Lismore Base Hospital Redevelopment Stage 3B and Stage 3C

*State Significant
Development
Modification
Assessments*

(SSD 6848 MOD 6)

(SSD 8963 MOD 1)

Figure 4 | SSD-6848-Mod-6 Proposed level 3 plan (Base source: SSD-6848-Mod-6)

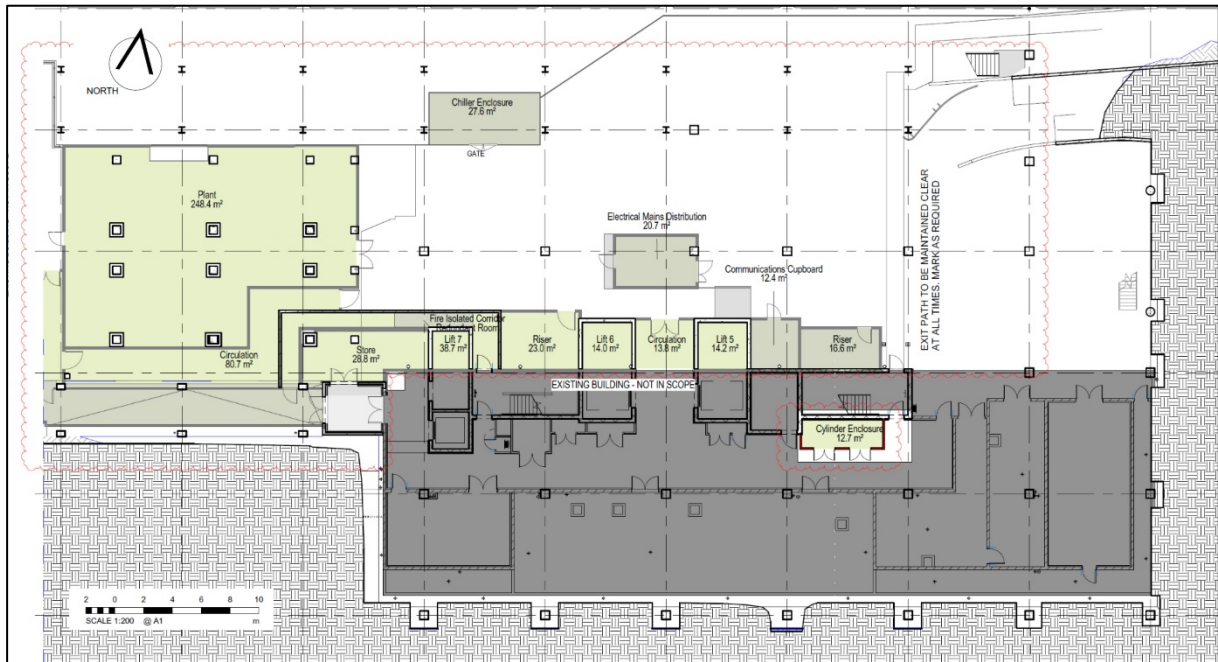
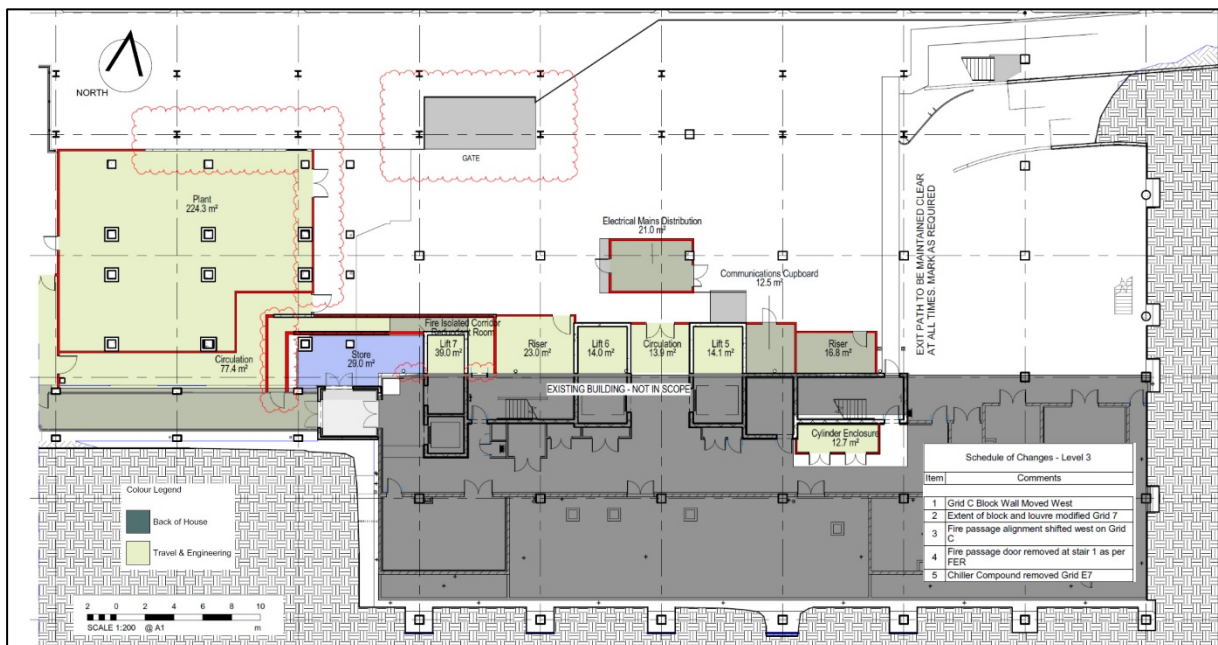
| Application No. | Description |
|-----------------------|---|
| SSD 6848 MOD 6 | <i>Internal</i> Modifications to Level 3 layout in relation to plant and services areas. |

The proposal seeks approval to reconfigure the layout of ground level, plant level and rooftop plant level. These changes are a result of design development and required to respond to engineering requirements in relation to fire stairs, alignment of service areas and reduction in plant size.

The Department considers the proposed changes are acceptable as they would not change the overall gross floor area of the building and patient and staff numbers would stay the same and there would be no reduction in medical services.

Figure 6 | SSD-6848-Mod-6 Proposed north elevation (Base source: SSD-6848-Mod-6)

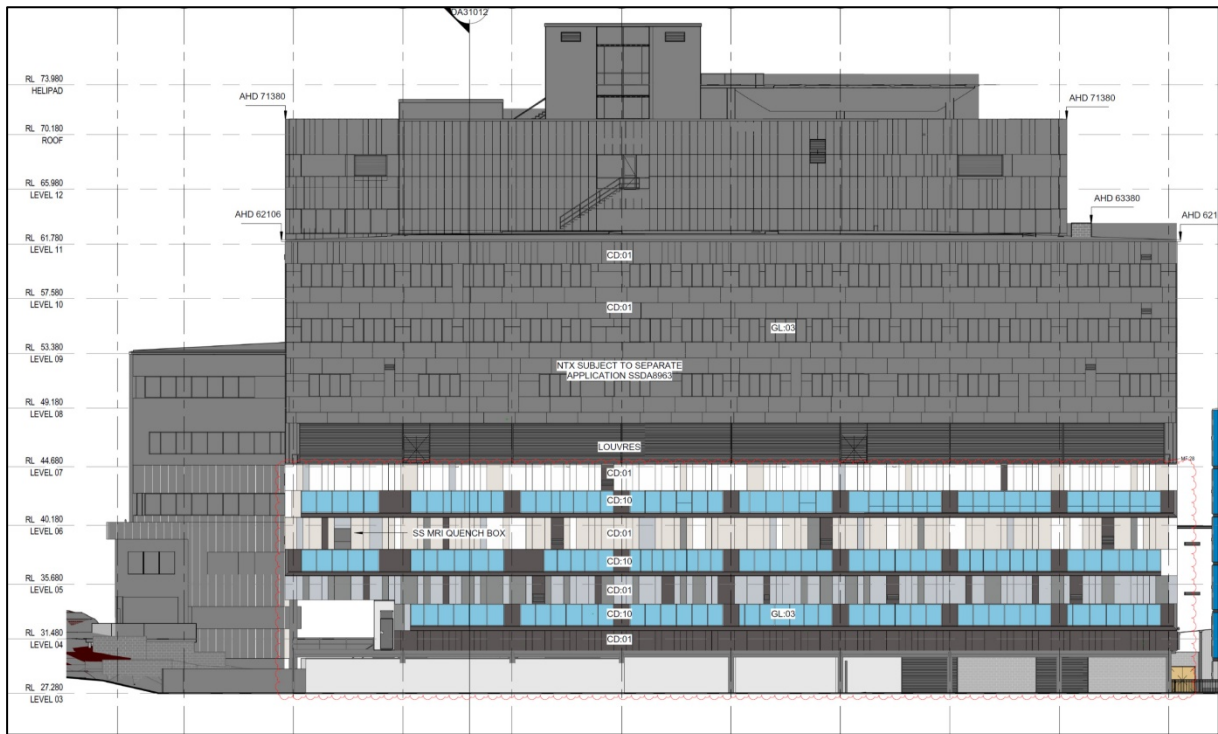
| Application No. | Description |
|-----------------------|---|
| | <i>External</i> Northern Façade: minor adjustments to location of a pipe; new security gate; modified wall alignment and louvres; and a new air duct. Eastern and Western Façades: new mechanical louvres; adjusted pipe design and location. |

The proposal seeks approval to make multiple minor amendments to the external façade of the hospital including the additional and relocated louvres, which screen structural columns and modified plant related design.

- there are no proposed changes to the approved building envelope or materials and finishes.
- the modifications are minor and in keeping with the approved design scheme.

Figure 12 | SSD-8963-Mod-1 Proposed level 7 plan (Base source: SSD-8963-Mod-1)

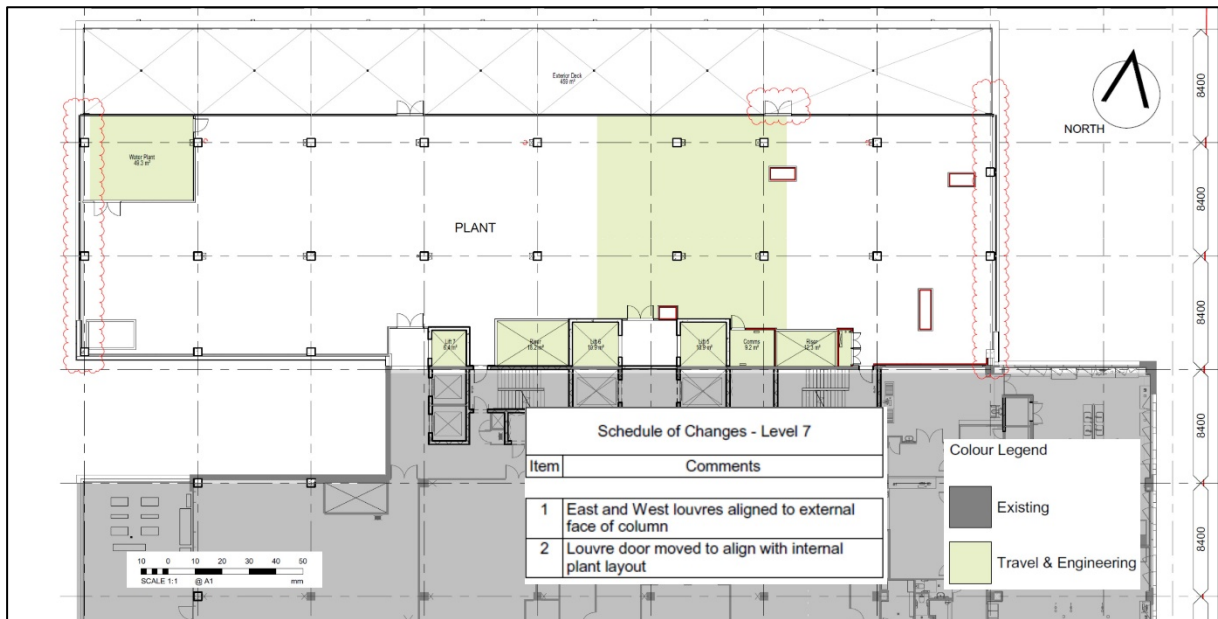
| Application No. | Description |
|-----------------------|---|
| | <i>Internal</i> Modifications to Level 7 to reposition the louvres on the east and west façades to align with Stage 3B below (enclosing the structural columns) and relocation of a set of louvre doors. Modifications to rooftop mechanical plant. |

Figure 16 | SSD-8963-Mod-1 Proposed north elevation (Base source: SSD-8963-Mod-1)

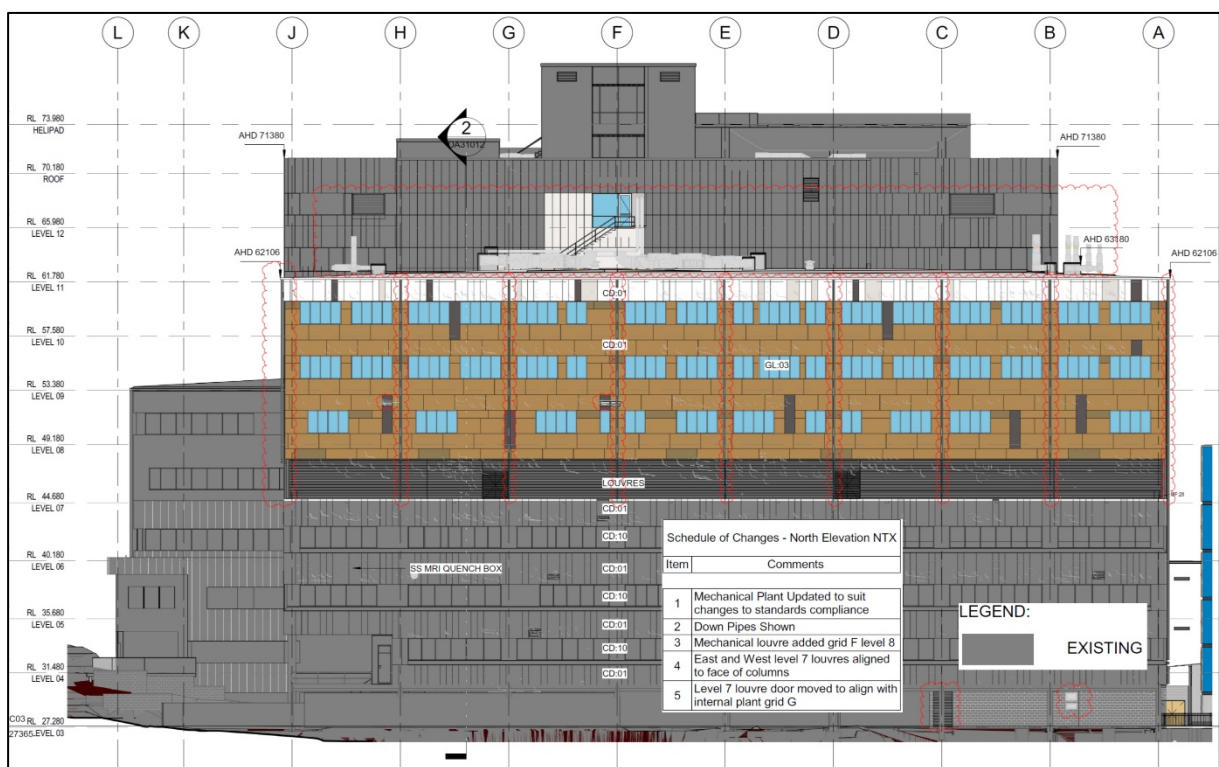
| Application No. | Description |
|-----------------------|---|
| | <i>External</i> Northern Façade: illustration of downpipes (previously omitted in error); additional mechanical louvres; relocated louvre doors; and revised mechanical plant design. Eastern and Western Façades: illustration of downpipes (previously omitted in error); additional mechanical louvres; repositioned louvres on Level 7, which enclose the structural columns; and revised mechanical plant design. Southern Façade: revised rooftop mechanical plant design. |
